TRANS/WP.29/GRSG/2002/
2002

PROPOSAL FOR A REVISION TO REGULATION No. 107
(double-deck large passenger vehicles)

Transmitted by the Expert from the United Kingdom

Figure 17

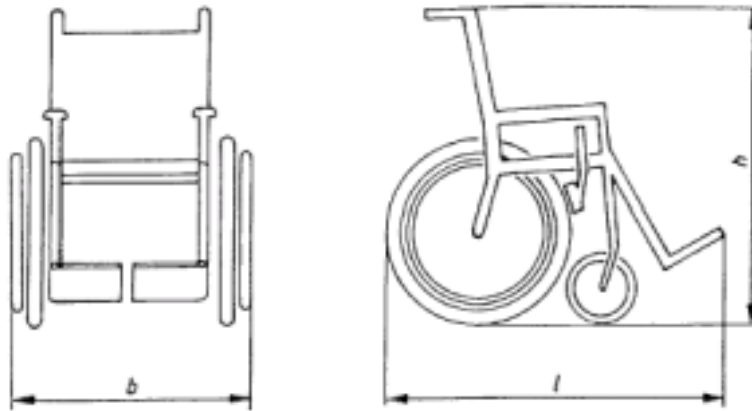
REFERENCE WHEELCHAIR

Overall length, l: 120 cm
Overall width, b: 70 cm
Overall height, h: 109 cm

A wheelchair user seated in the wheelchair adds 5 cm to the overall length and makes a height of 135 cm above the ground.

- 3.6.4 It shall be possible to move from the outside of the vehicle through at least one of the doors for wheelchair access into the special area(s) with a reference wheelchair of the dimensions shown in Annex 3, figure 17.

Figure 18

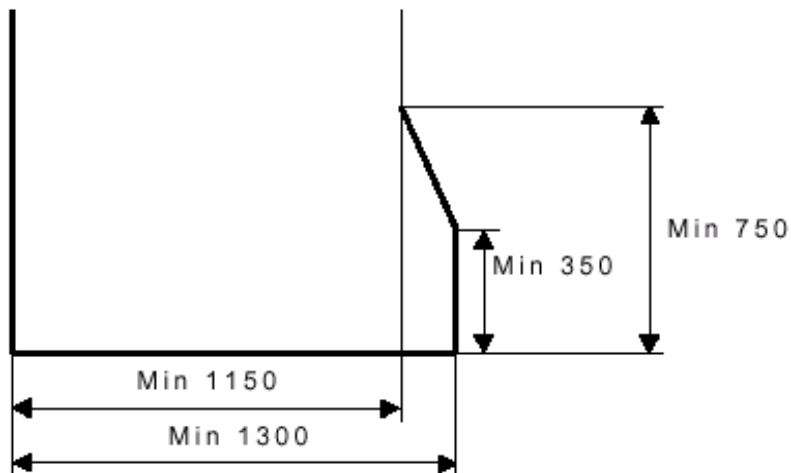
Minimum clear space for the wheelchair user at the wheelchair space

(Note: Diagram as shown above but with units in cm)

In the case of a wheelchair space designed for a forward facing wheelchair, the top of preceding seat-backs may intrude into the wheelchair space if a clear space is provided as shown in Annex 3, figure 18.
